**UNITED  
TECHNOLOGIES  
CARRIER**

BULLETIN: CA-SB-19-D-66-32  
DATE: 9/29/66  
PAGE: 1 OF: 7

**THRUST BEARING THERMOSTAT MODIFICATION 19D11, 21, 31**

**PURPOSE:** To transmit information on design improvements to the thrust bearing high temperature cut-out thermostat and to forward instructions and parts lists for adapting existing machines to these design improvements.

FIG. 1 CONVERSION WIRING

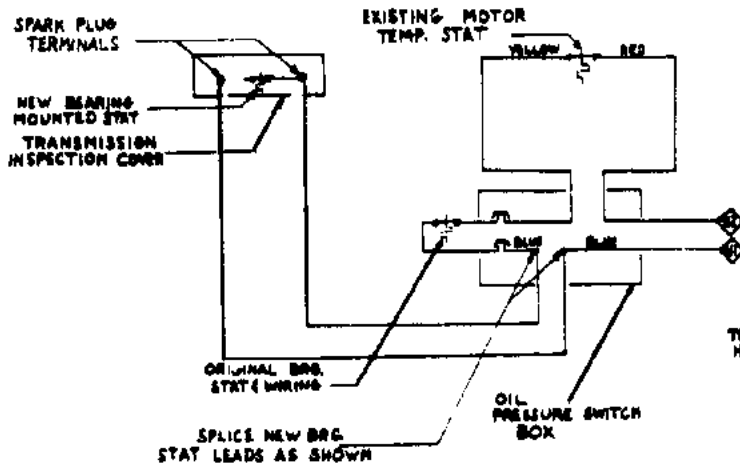
14. Wire the thermostat in series with the oil pressure switch and motor winding high temperature thermostat as shown in Figure 1 by cutting the blue wire from terminal 41 and splicing the new thermostat leads to the cut ends.

FIG. 2 COMPLETED ASSEMBLY

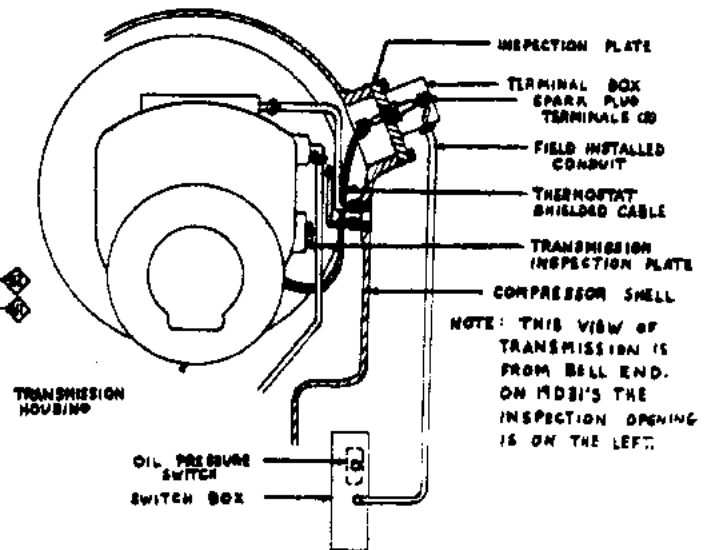
13. Install  $1/2$ " conduit from terminal box to oil pressure switch terminal box as shown in Figure 2 and insert 16 - 18 gage wire. Figure 2 depicts a typical 19D21 machine. On 19D11 and 19D31 machines the oil pressure switch box is on opposite side of the compressor.

FIG. 3 COMPRESSOR X-SECTION

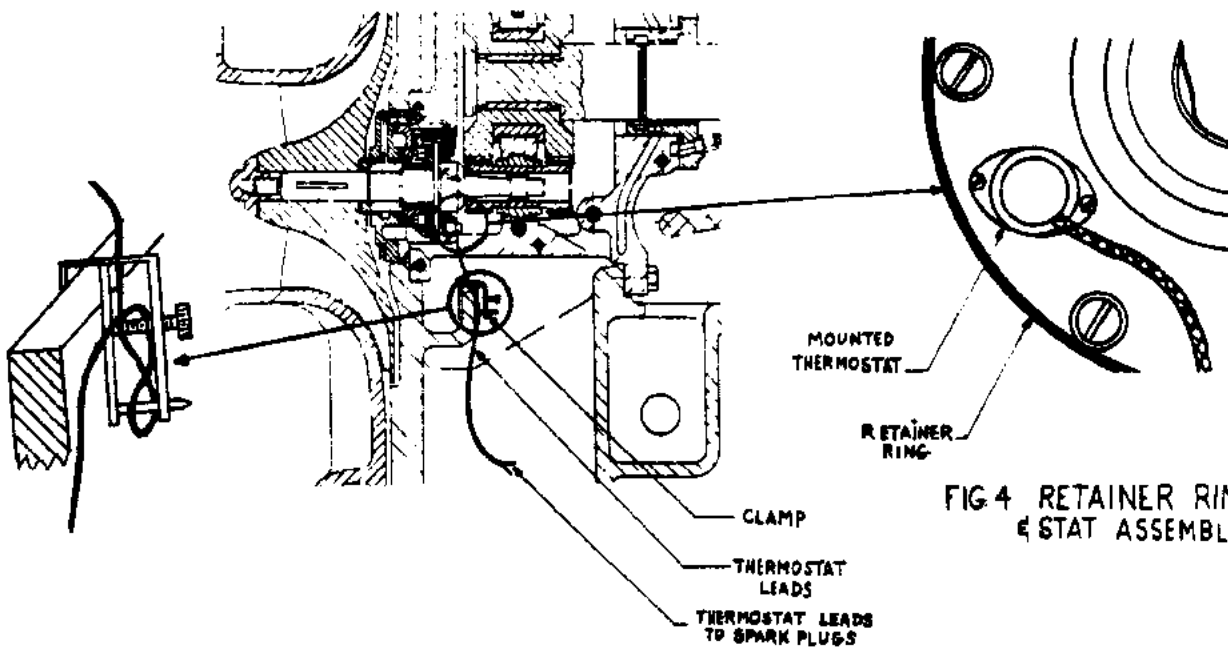
6. Install the thermostat lead wire clamp on the lip of the oil trough as illustrated in figure 3.
7. Align and replace thrust bearing and shaft assembly and insure thermostat lead wires are securely attached to the clamp and that there is no slack in the lead between the thermostat and the clamp.

FIGURE 5

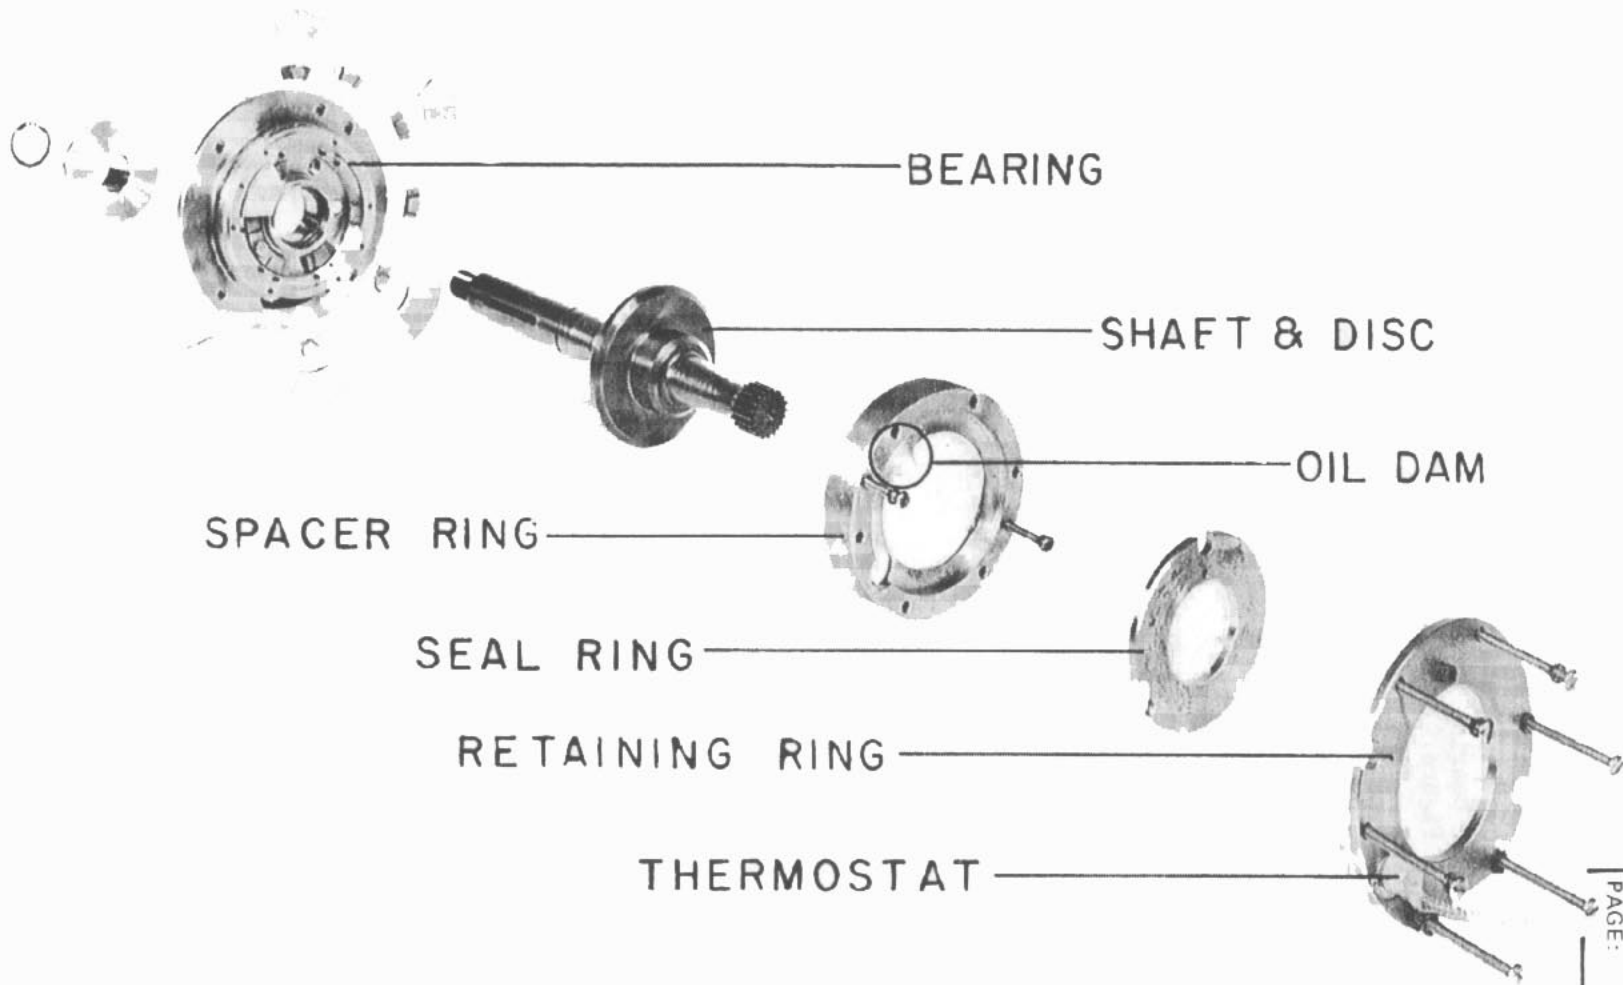
4. Remove retainer ring, seal ring, and spacer dam (refer to Figure 5) and install similar parts plus thermostat from kit. See CAUTION Note on page 6.
5. Remove compressor base inspection cover plate.

FIGURE 6

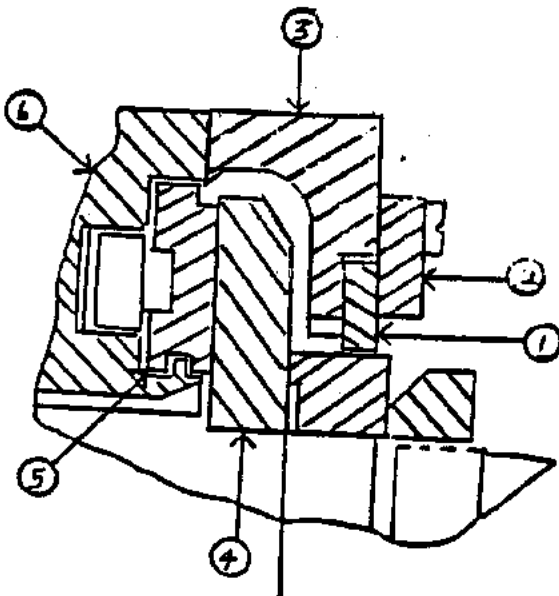
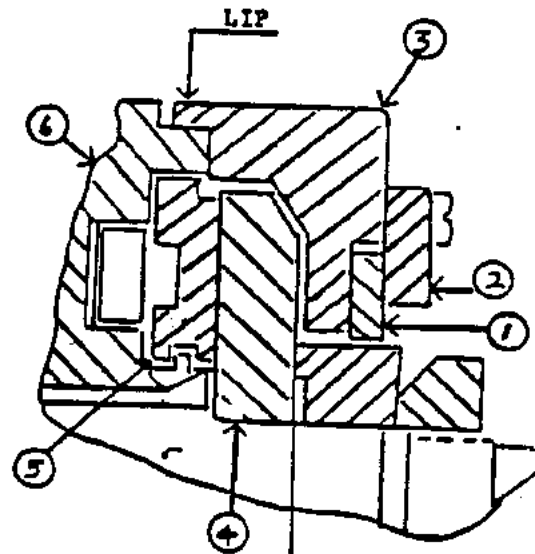
Some early design shaft and bearing assemblies were manufactured with a bearing (Item 6) and spacer ring (Item 3) joint as shown in Figure 6. This design was included on the following machines:

Later design assemblies included an alignment lip on the Spacer Ring as shown in Figure 7. When replacing the Spacer Ring on the earlier machines, it will be necessary to machine off the alignment lip, if the bearing (Item 6) does not include a matching shoulder.
